ADMINISTRATIVE, VARIANCE OR MISCELLANEOUS APPEAL APPLICATION

LOCATION/PROPERTY ADDRESS: 521 Walnut Hill Rd, North Yarmouth ME 04097

Sol and Alicia Dostilio (immediate abutters to the Deacon Hayes Commons Project), request relief from the April 26, 2023 decision to approve the final application of the Deacon Hayes Commons Major Subdivision in North Yarmouth, Maine. The request for relief is based on several factors including the fact that the project record lacked the site-specific groundwater level and elevation data necessary to support the Planning Board's decision. Ultimately, the decision to approve the Deacon Hayes Commons Project is inconsistent with the North Yarmouth Land Use Ordinance.

GROUND WATER
FLOW DIRECTION
5 mg/l for
NO3-N PLUME

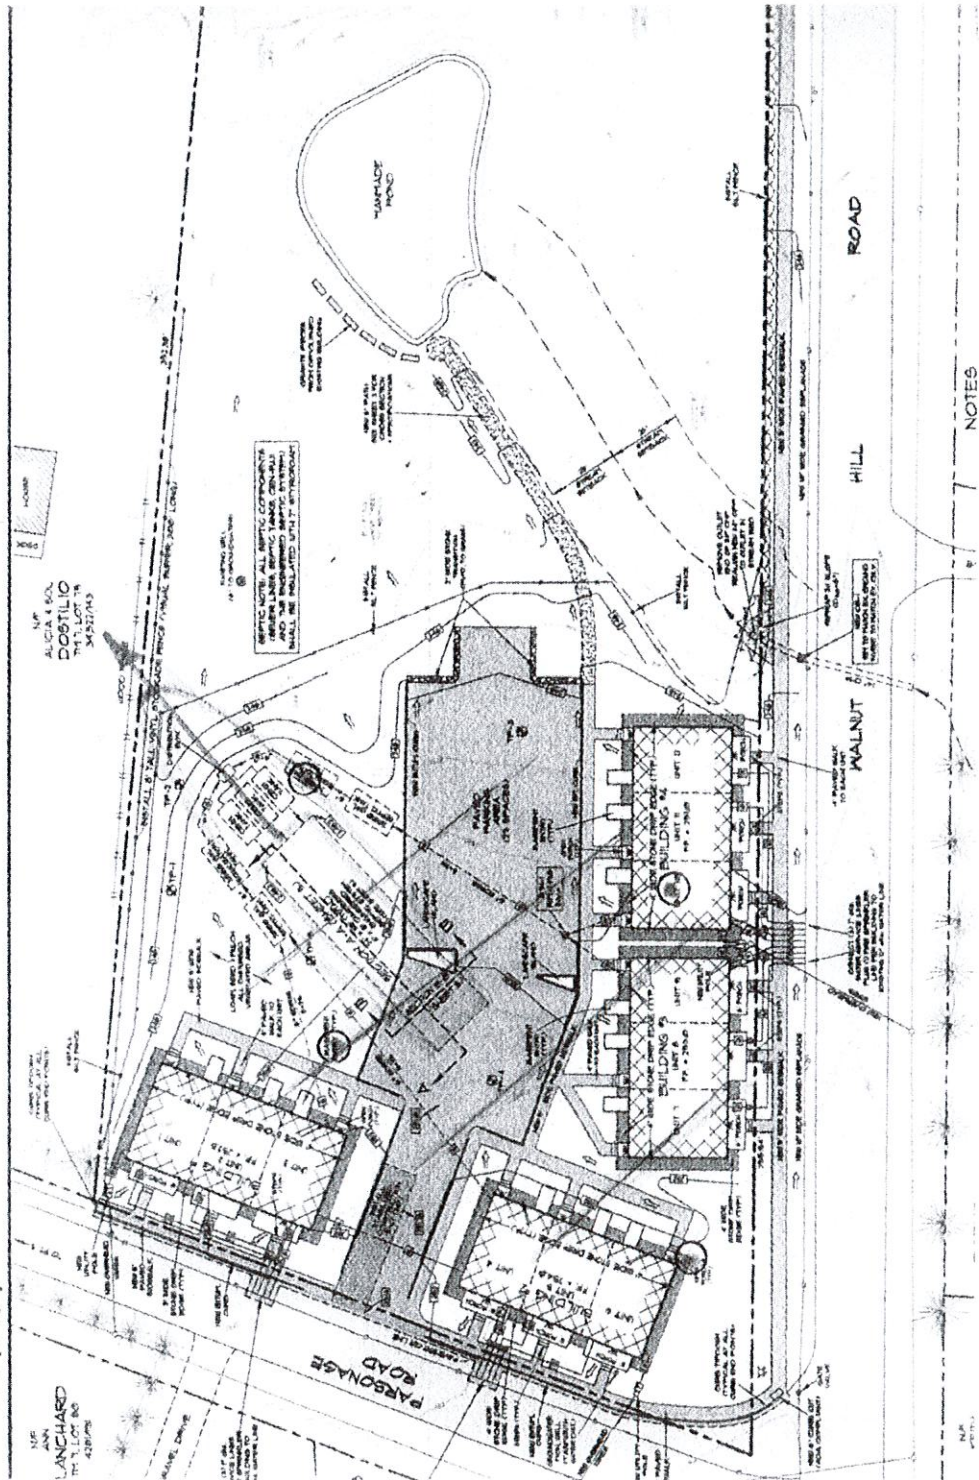
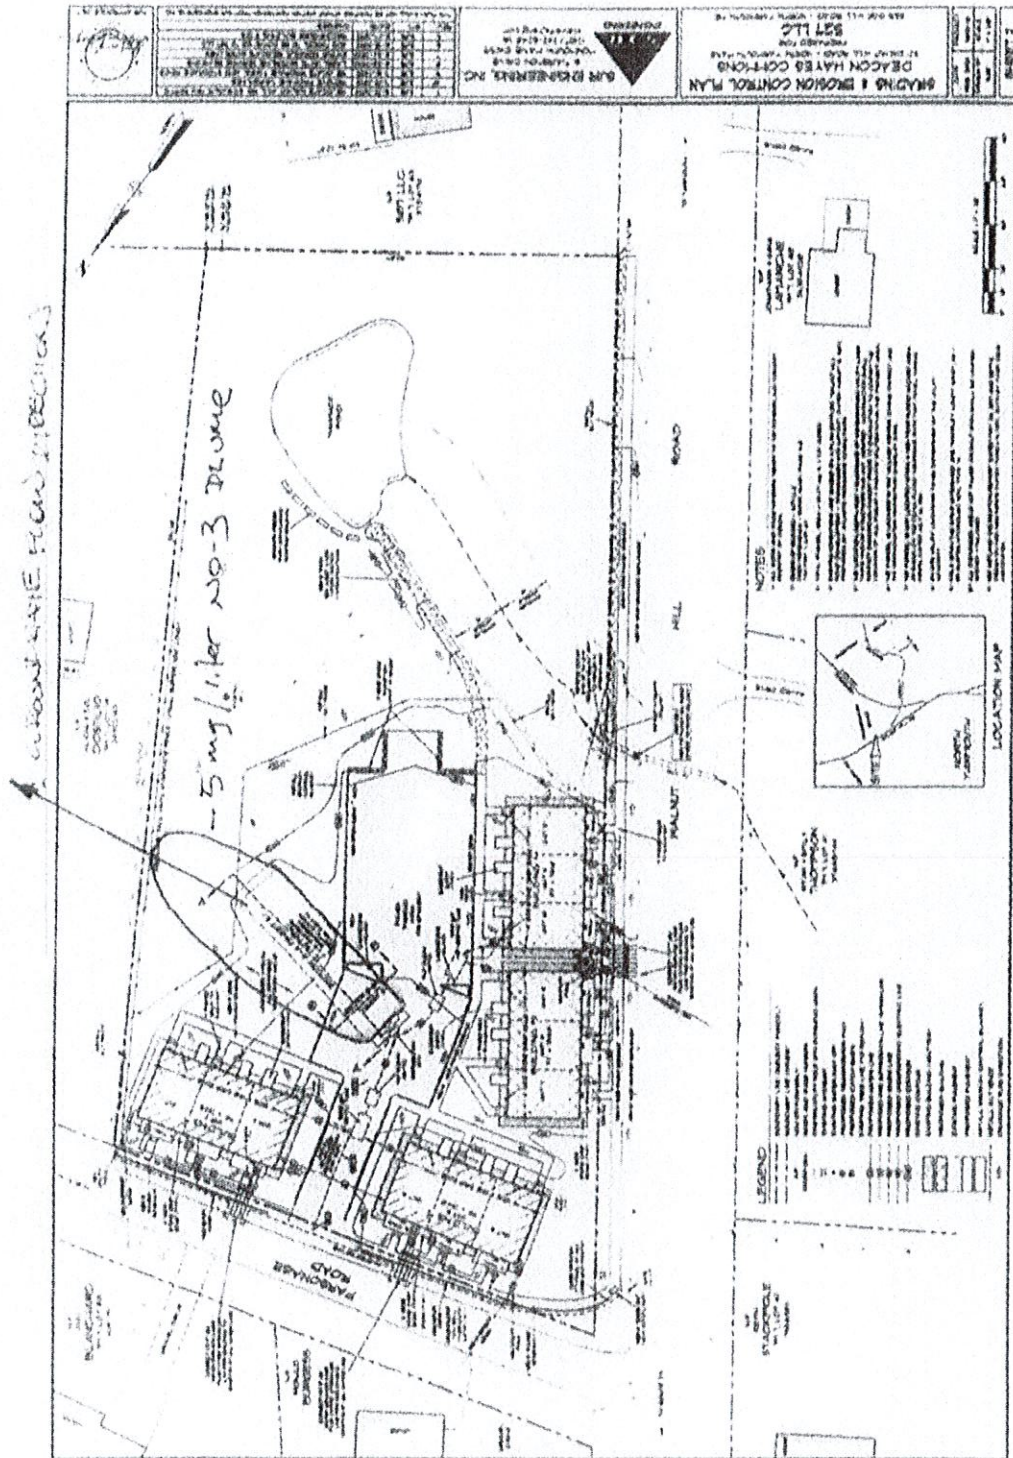
In the 11/29 report Mr. Cenci found that the change in the hydraulic gradient increased the length of the 5mg/liter NO₃-N plume from 40' to 67'. To that point the distance between the system and the property line had been determined by a flow direction informed by Yarmouth Water District regional modeling (**Attachment B** shows this water flow direction). A plume length of 67' along that direction would not have met town LUO standards.

But in the 11/29 report Mr. Cenci also concluded that the direction of the water flow should be updated to be more southerly than previously assumed. This created a new angle between the system and the property line and a longer separation distance between the two. Mr. Cenci found that this increased distance between the system and property line would allow for the increased plume length and allow the system to meet LUO standards.

The November 2022 reporting from Mr. Cenci (and subsequent Planning Board testimony in April 2023) failed to provide site-specific groundwater level and elevation data to support the reports' conclusions. The depth to water level readings (numbers) and water table elevations (numbers) based on these readings that Mr. Cenci used to reach his new conclusion about the direction of the water flow were not provided. There was no data provided to support the conclusion.

The Planning Board's approval of this project ultimately compounded the state's error by not requesting that the site-specific groundwater levels and elevations determined from the piezometers be entered into the record for review. The report offers conclusions without showing the supporting data for its work; there is ultimately no data to support its conclusion that the direction of the waterflow should change. And to reiterate our key point, the project would not have met the town LUO limit on nitrate levels at the property line without that change in water flow direction.

Attachment E (photo from March 13th)

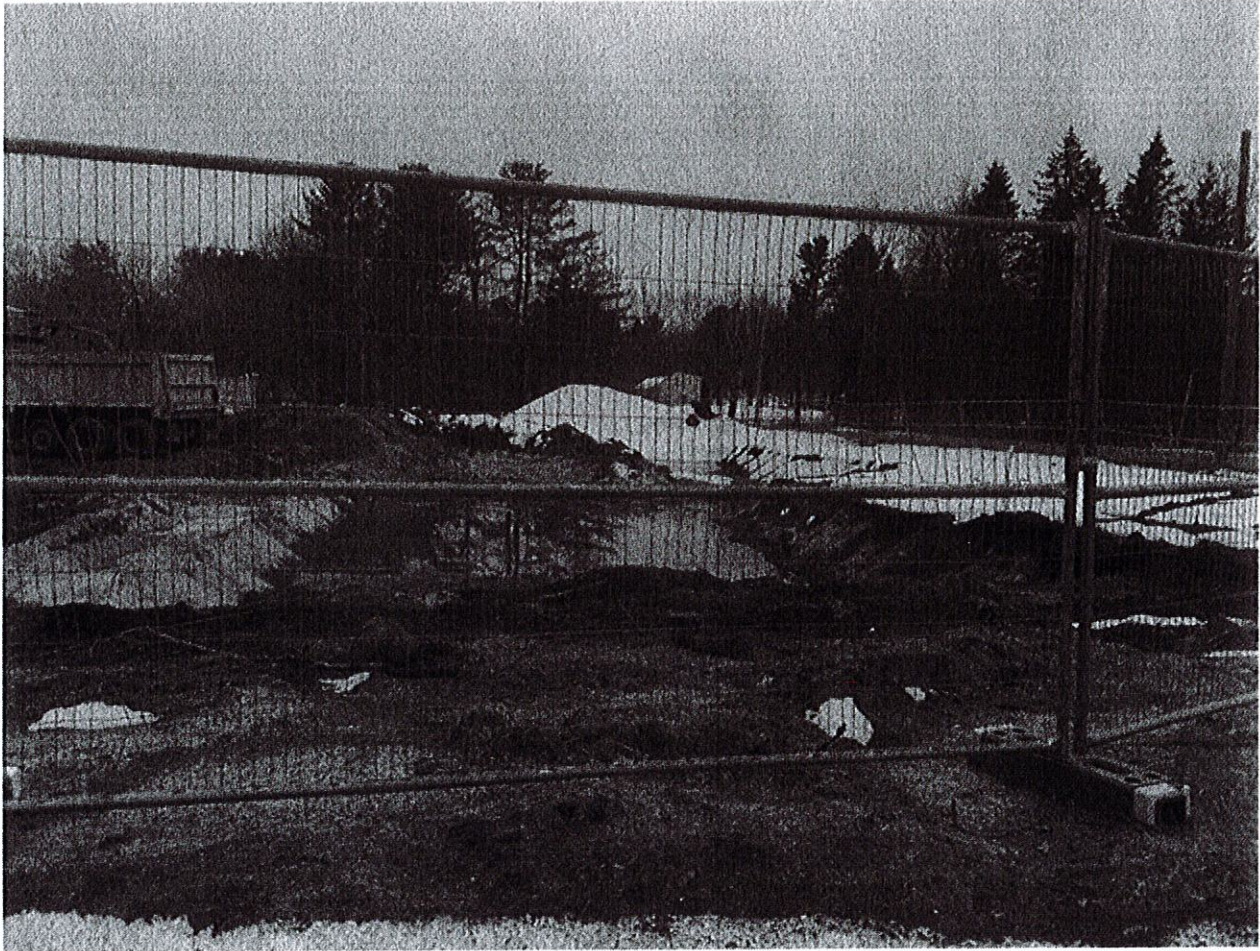
The photo in Attachment E of the foundation excavation shows water pooled onsite that appears to be 3 feet or less below ground surface. Clearly, this high water condition is inconsistent with the September "free water" data presented for TP-5. This recent photo is evidence that the water level can rise much higher in the ground than was represented in the TP-5 log. As reported by Mr. Marcotte and Mr. Cenci, a "thick layer of silty/clay at 6 feet below the ground surface" is present at the site. It's apparent that water became pooled in the excavation due to the presence of this poorly drained layer.
